**DOCUMENT 00 90 00**  
**ADDENDUM**

**ADDENDUM NO. [2]                      Date: March 21, 2018**

**RE:                      EAU CLAIRE AREA SCHOOL DISTRICT  
McKINLEY CHARTER SCHOOL  
1266 McKINLEY RD  
EAU CLAIRE, WISCONSIN 54701  
HSR PROJECT NO. 17057**

**FROM:                  HSR Associates, Inc  
100 Milwaukee Street  
La Crosse, WI 54603  
(608) 784-1830**

**M100R**

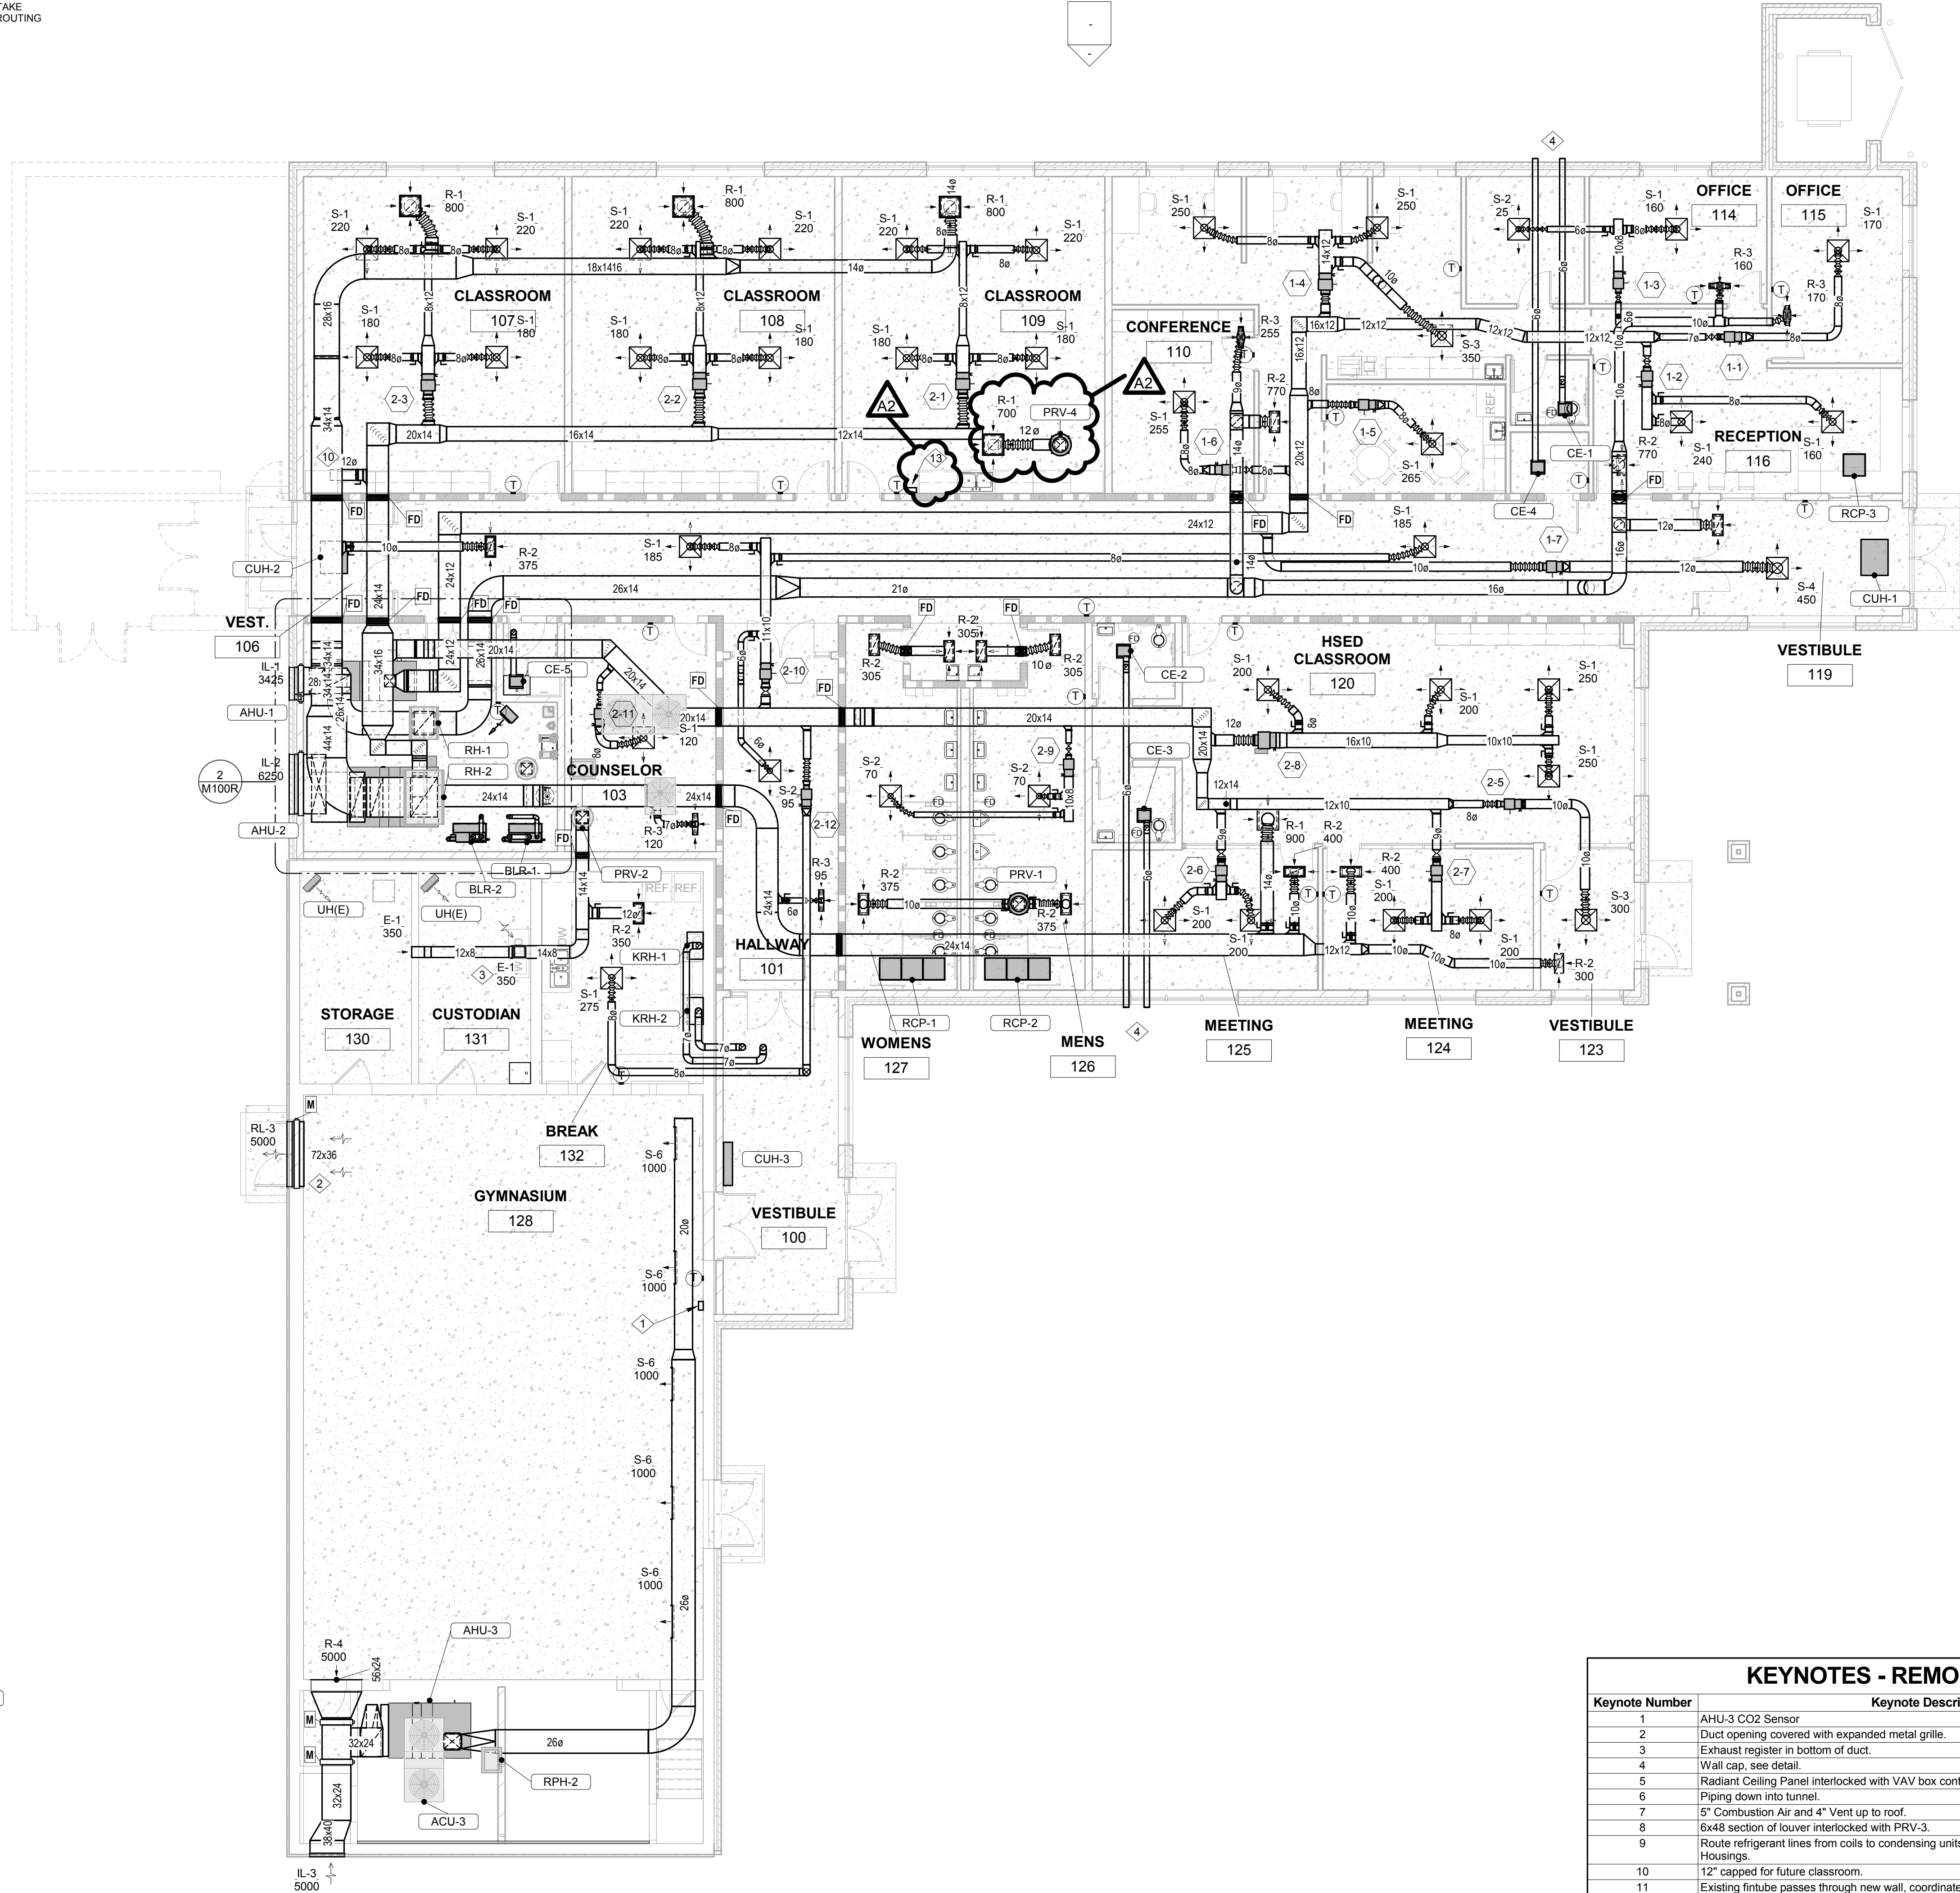
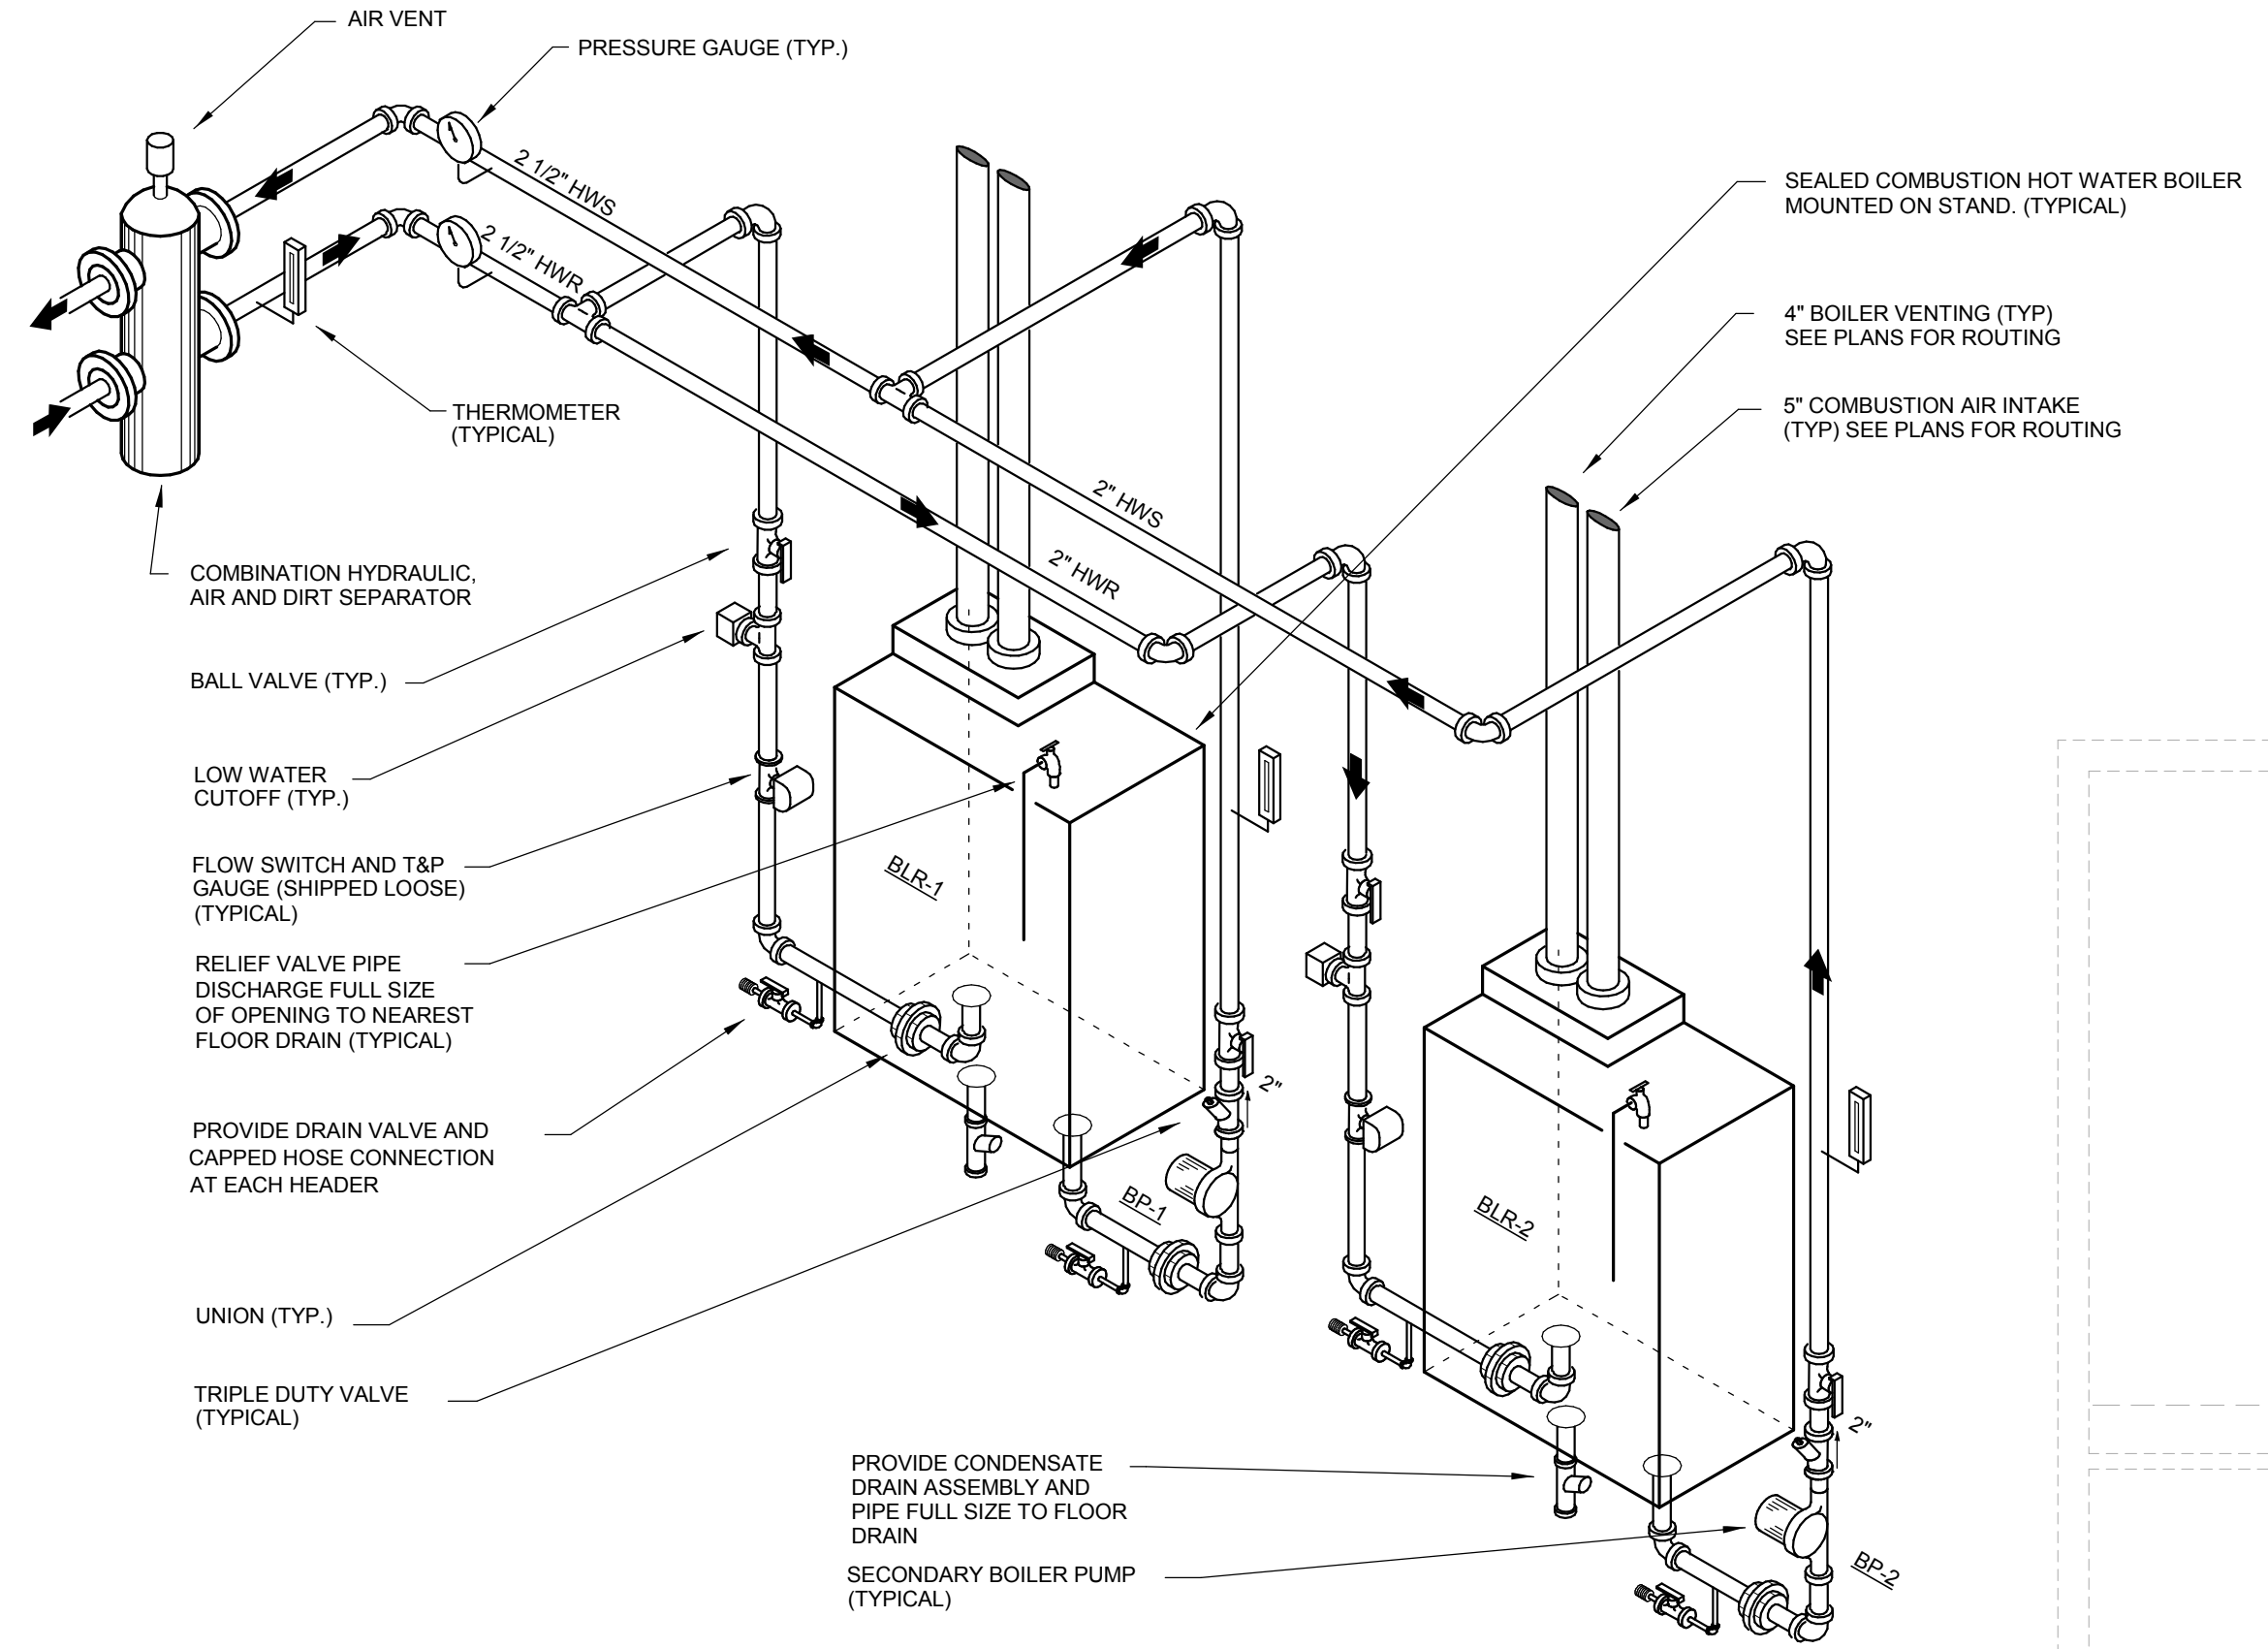
12. Sheet M100R MECHANICAL VENTILATION REMODEL PLAN 30 x 42 attached hereto
  - a. Revisions clouded on Drawing
